**From:** Bryan King <[REDACTED]>  
**Sent:** Monday, November 23, 2015 2:04 PM  
**To:** McDonald, John  
**Cc:** Gibbs, Carol  
**Subject:** Single Family Attached

As a follow up to our conversation last week, I am writing you today regarding the attachment parameters of the designation "SF attached" and how the COA is insuring code requirements and moreover your requirements of construction.

**From:** McDonald, John  
**Sent:** Thursday, December 03, 2015 5:21 PM  
**To:** Bryan King  
**Cc:** Rivera, Mayra; Word, Daniel; Wren, Carl; Roig, Jose G; Hernandez, Tony [PDRD]; Stilwell, Kelly  
**Subject:** RE: Single Family Attached

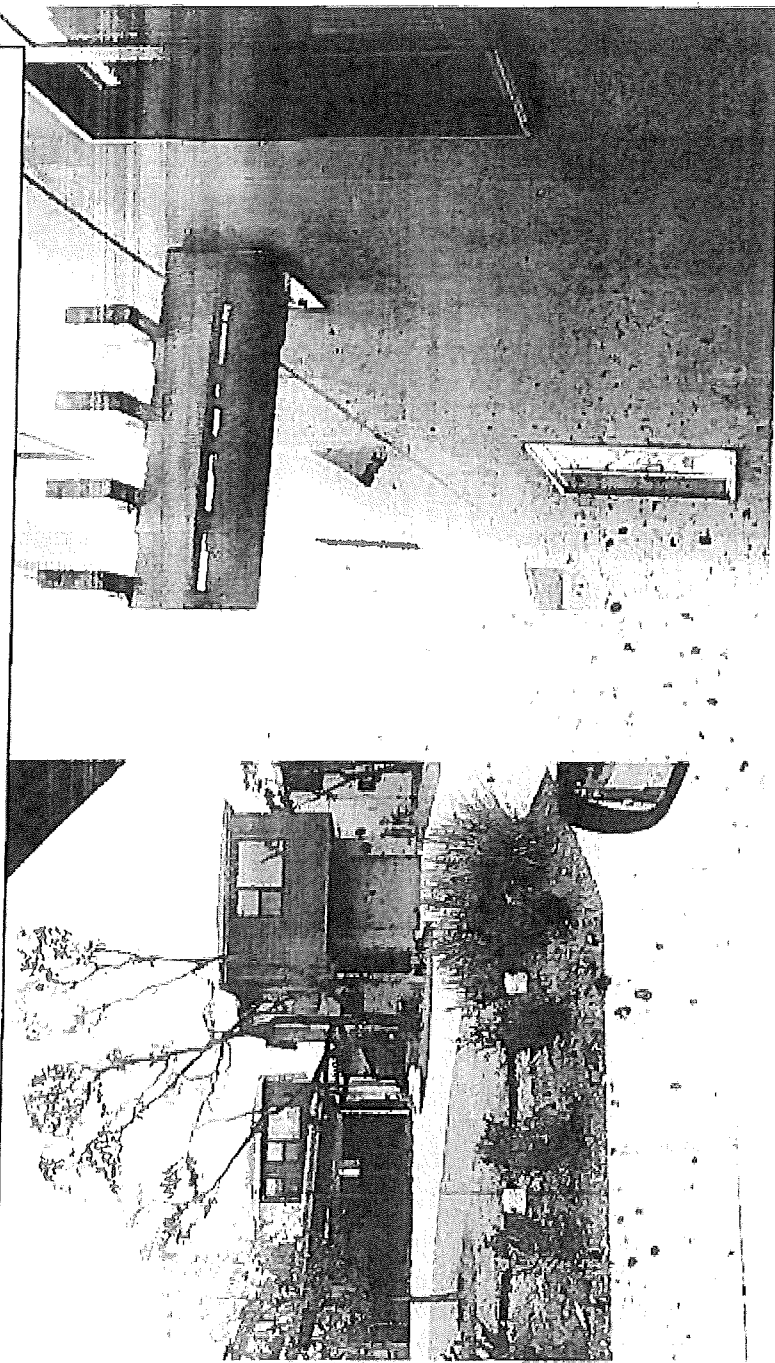
PSW Current connection via "other structural element": (visuals of the proposed attachment)  
These pictures were taken December 14<sup>th</sup>, 2016 at PSW project. Note: no siding would be  
required to remove this minimal feature.

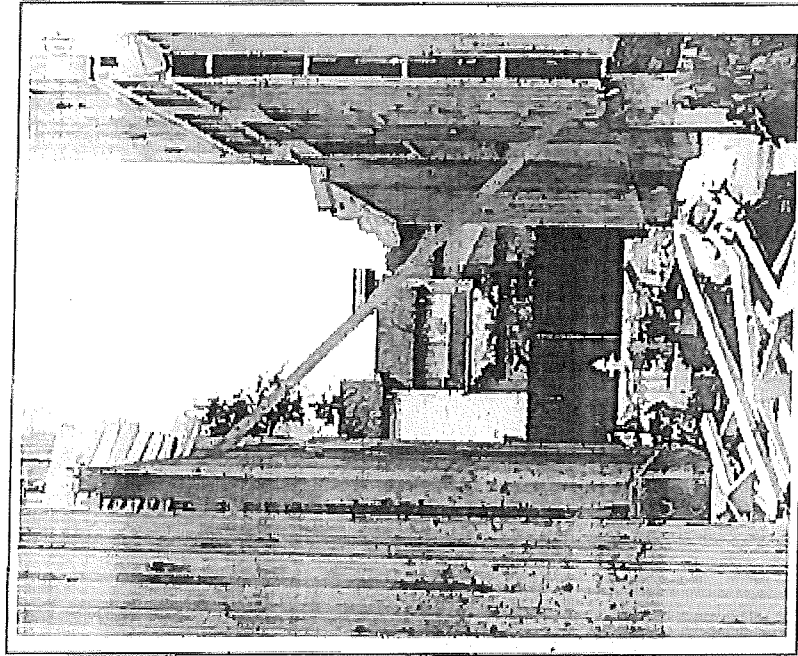
Could this temporary brace, shown below, be a better "other structural element"?  
It actually is supporting something and it is tied into the framing, for now.

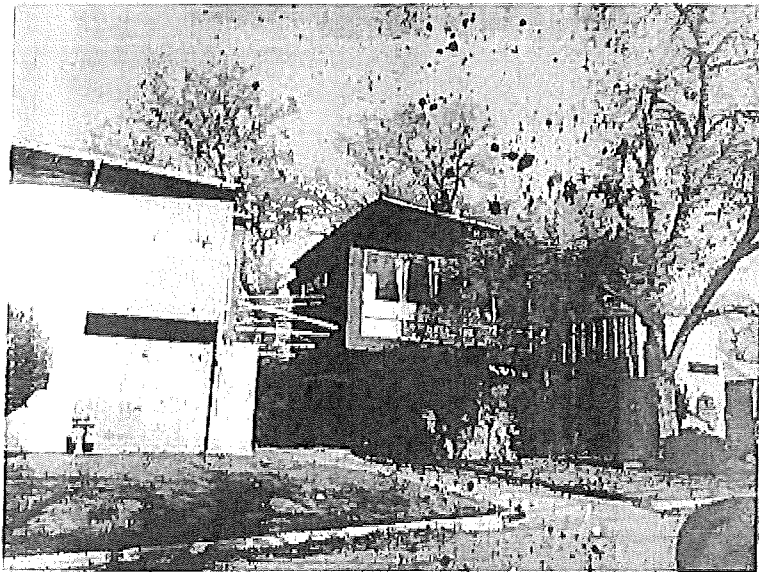
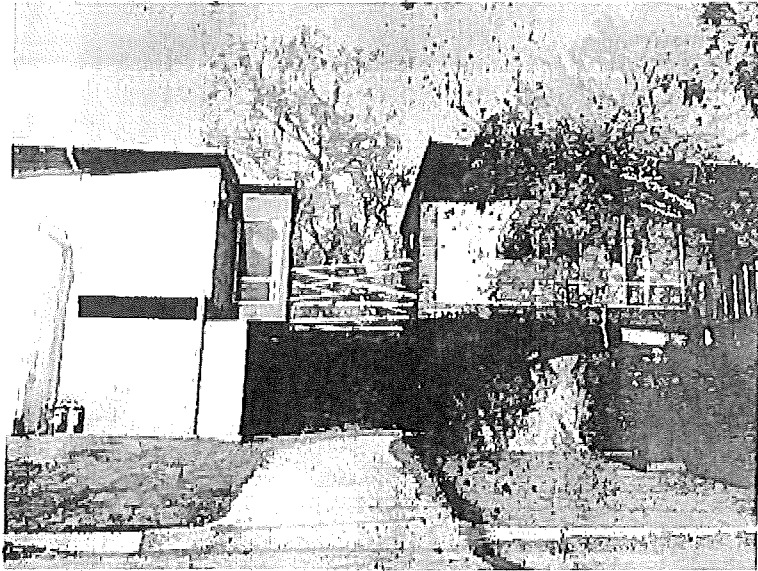
Acceptable connection between buildings?  
Seriously?  
Approved at 47<sup>th</sup> & Duval<sup>a</sup>
